SUBJECT: ISSUANCE OF EMERGENCY AMENDMENT NOS. 156 AND 160 TO FACILITY
OPERATING LICENSE NOS. DPR-24 AND DPR-27 - POINT BEACH NUCLEAR
PLANT, UNIT NOS. 1 AND 2 (TACS M90642 AND M90643)

ATTACHMENT TO LICENSE AMENDMENT NOS. 156 AND 160
TO FACILITY OPERATING LICENSE NOS. DPR-24 AND DPR-27
DOCKET NOS. 50-266 AND 50-301

SAFETY EVALUATION BY THE OFFICE OF NUCLEAR REACTOR REGULATION
RELATED TO AMENDMENT NOS. 156 AND 160 TO
FACILITY OPERATING LICENSE NOS. DPR-24 AND DPR-27
WISCONSIN ELECTRIC POWER COMPANY
POINT BEACH NUCLEAR PLANT, UNIT NOS. 1 AND 2
DOCKET NOS. 50-266 AND 50-301

Figure 15.2.1-2
REACTOR CORE SAFETY LIMITS
POINT BEACH UNIT 2

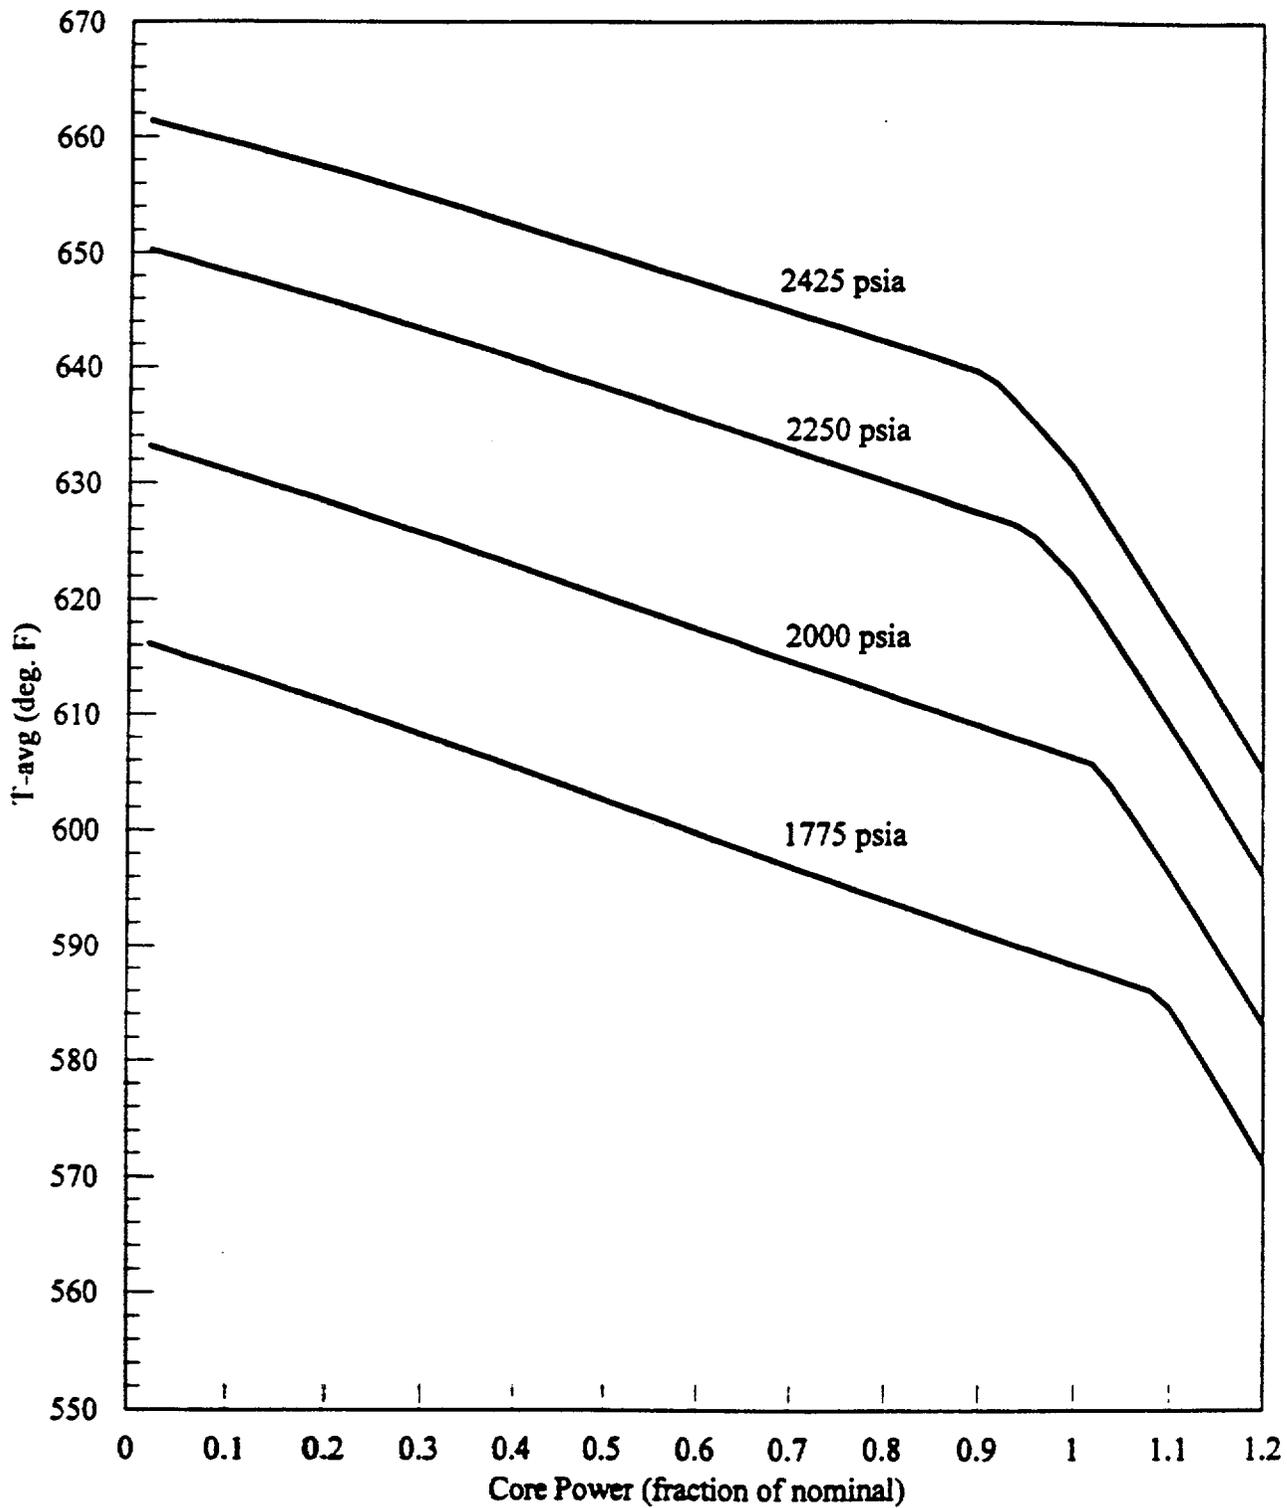
These amendments revise Technical Specification (TS) Section 15.3.1.G, "Operational Limitations," to reduce the reactor coolant system raw measured total flow rate and operating pressure, modify TS Section 15.2.3.1.B to increase the required reduction in the ΔT trip setpoint, and modify TS Figure 15.2.1-1 to reflect new reactor core safety limits, all for Unit 2 only. The applicable bases are also revised.

Finally, TS Figure 15.2.1-2 and the applicable bases are modified to support the reduction of RCS flow in Unit 2.

The result of the reduced flow on the non-LOCA transient analysis was that the thermal safety limits became more limiting at all power and pressure levels. A revised TS Figure 15.2.1-2 was derived. In addition, due to the higher temperature change across the core, an increased $F(\Delta I)$ penalty is assumed (from 2.0 to 3.1). The non-LOCA transients with non-DNB acceptance criteria were also reanalyzed and found to meet the acceptance criteria with the reduced flow.
